US ITER 1020100-TD0017-R00  
2.6.P1A\_B.US.01.0

# **ITER TCWS Conceptual Design Chit Resolution Report**

**February 2012**

**Fig. 1. IBED PHTS Double Isolation Valves.**

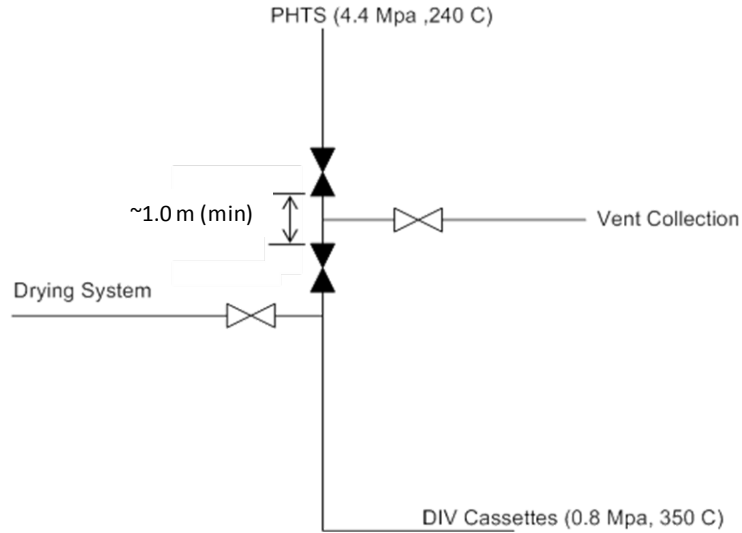
Item #	Issue Statement
1	Design strategy for isolating the baking and cooling circuits during divertor baking needs to be defined. Are suitable isolating valves available?

To ensure no cross leakage between high pressure water and hot gas during the DIV gas baking, double isolation valves are used in two locations within the IBED PHTS system as shown in the simplified sketch, Fig. 1, with valves positioned for DIV gas baking. Any leakage from the gas side or the water side is collected and sent to the Vent Collection System.

The isolation valves are separated by a minimum distance of approximately 1.0m to minimize temperature gradients and heat conduction from the high temperature side (350°C nitrogen gas) to the low temperature side (240°C water). For a DN500/Schedule 80 pipe insulated with 82mm thick mineral wool, a distance of 1.0m is sufficient for a smooth transition from 350°C to 240°C. It was estimated that the convective heat transfer in the pipe section between two valves is negligible (approximately 40W). For conservatism and simplicity, the estimate neglected the heat loss from the valve bonnet, stem and yoke, and assumed that the gas side isolation valve is immediately adjacent to the drying system tie-in point. If the valve is further away from the tie in point, it will be at a lower temperature than the 400°C conservative upper bound of the gas temperature, and the resulting temperature gradient will be lower.

Fig. 2. PRT and associated Nozzles/Connections (Reference [5.1.7], [TBV-002]).

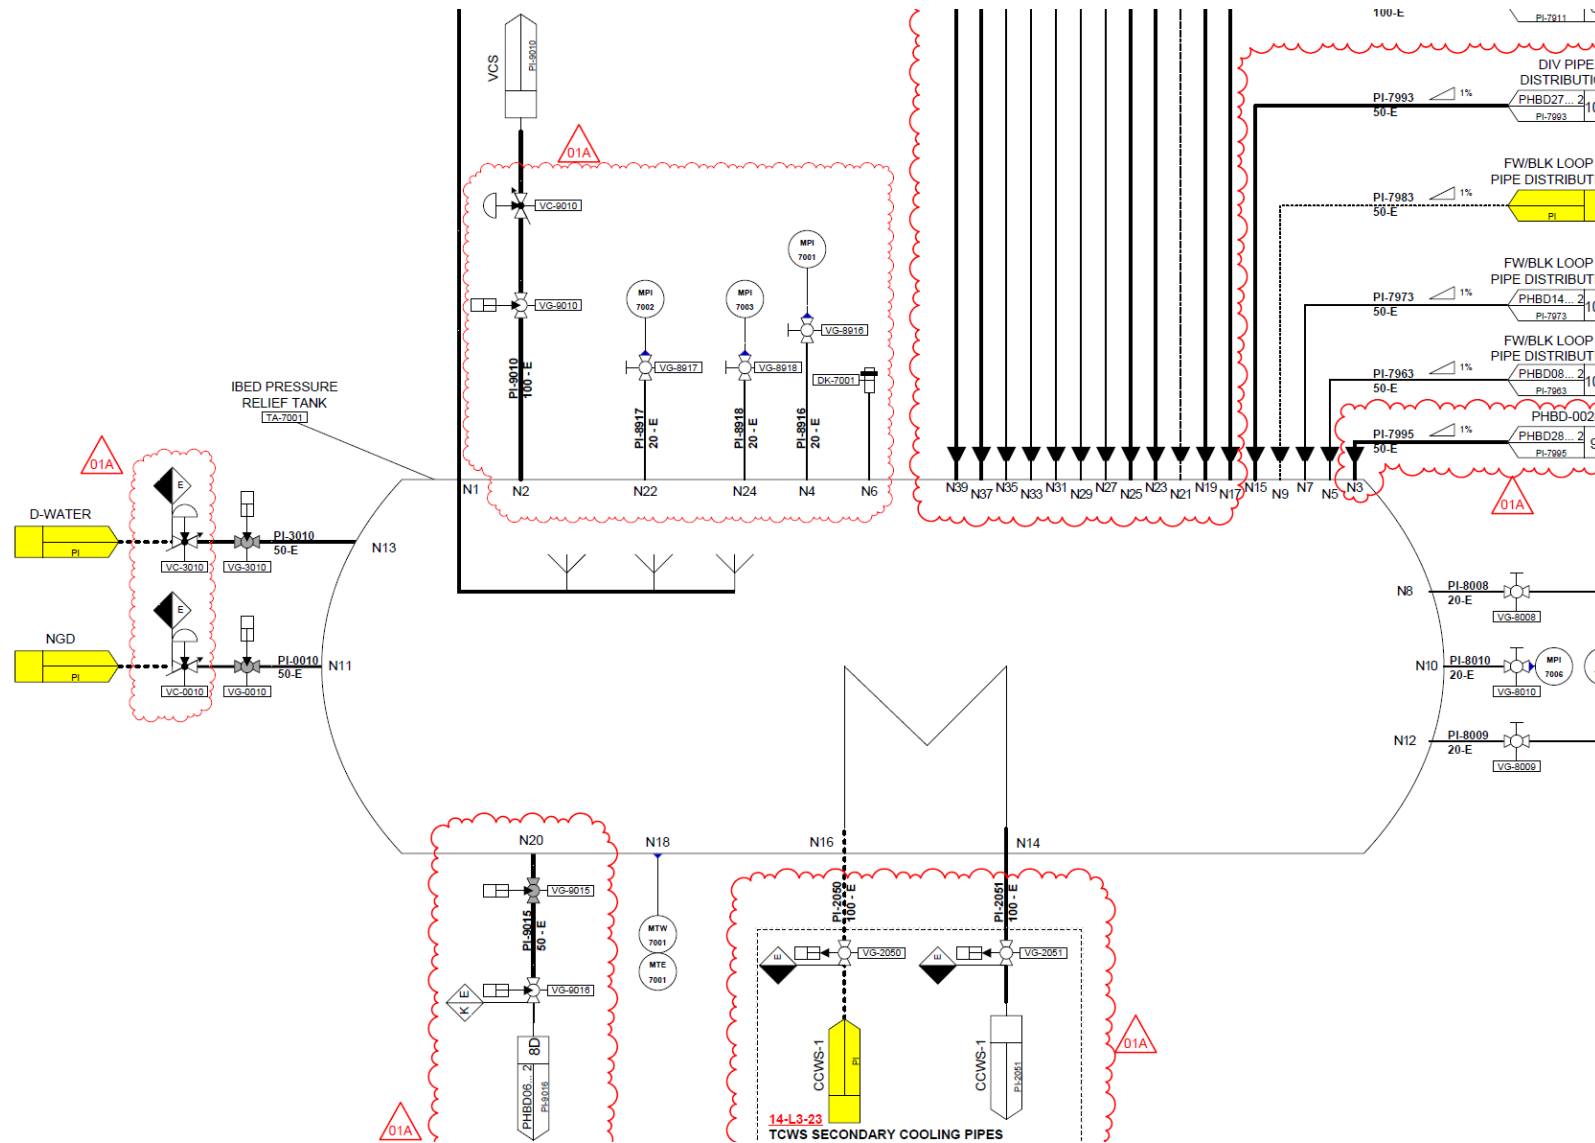
Item #	Issue Statement
2	Conceptual design of the Pressure Relief Vessel should accommodate overfilling including bursting disc and vent line. Adequate cooling via CVCS and appropriate vacuum relief for correct draining is required.

The pressurizer relief tank (PRT) is equipped with a rupture disc (DK-7001) which discharges to the TCWS vault for overpressure protection (See Fig. 2, [TBV-002]) and a vent line (N2) which discharges to the Waste Collection System and drain pipe (N20) that discharges to drain tanks.

The PRT is designed to accommodate a vacuum. This operating condition occurs when air is removed from the PRT by drawing a vacuum via the N-VDS vacuum pump prior to refilling the PRT with nitrogen. The draining is a slow, controlled process, and the tank pressure can be modulated with Nitrogen Gas Distribution. Therefore, a vacuum breaker is not required for draining the PRT.

A cooling coil inside the tank provides cooling of the liquid inside the PRT. The cooling water is provided by the CCWS.
